13 November 2018

Our Ref: 6374H

Modification to DA 2011/0360 and subsequent MOD2016/0077 at 48A Queenscliff Road, Queenscliff. The modification relates to additional window and door openings and changes to floor space as described in this letter for apartments 17 and 18.

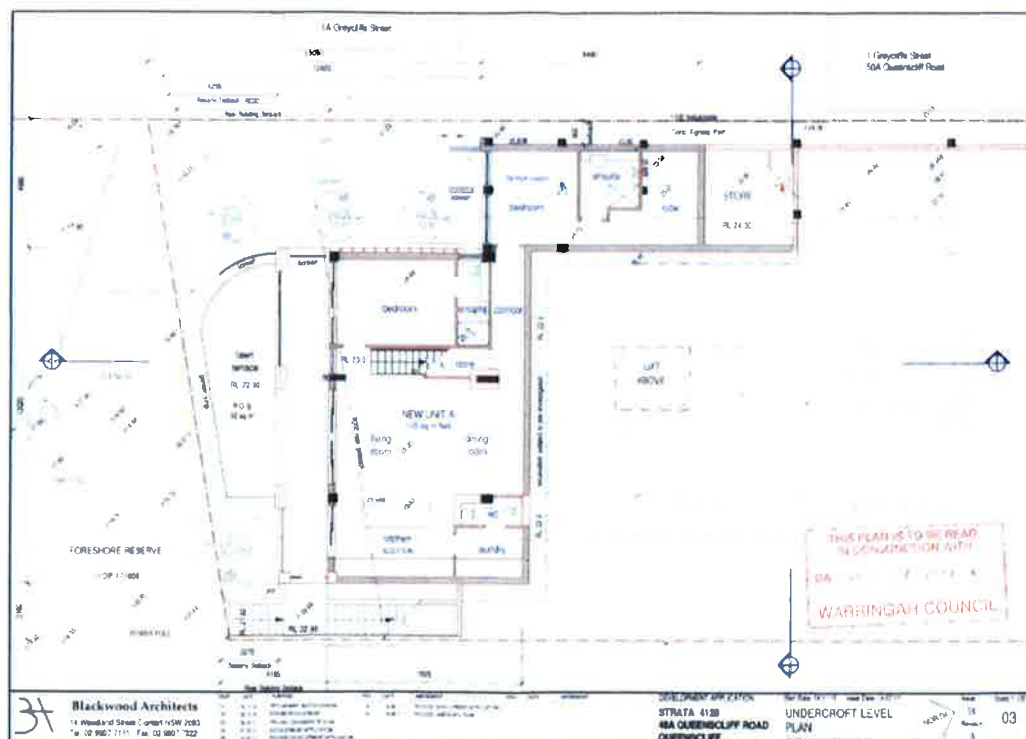
Addition of new high level windows on the western elevation of apartment 18 as shown on external elevations plan to include a highlight window on the western side in the third bedroom at 3.8m wide x 0.45m at 1.7m from floor level to protect privacy to the occupants and the neighbours and provide sunlight and ventilation. The highlight window on the western side storeroom is 1.1 wide x 0.45m at 1.7m from the floor level.

Creation of a third bedroom in apartment 18 within existing floor space.

Modification to the window and wall arrangement on the southern elevation in the study area to include frosted glass facing west.
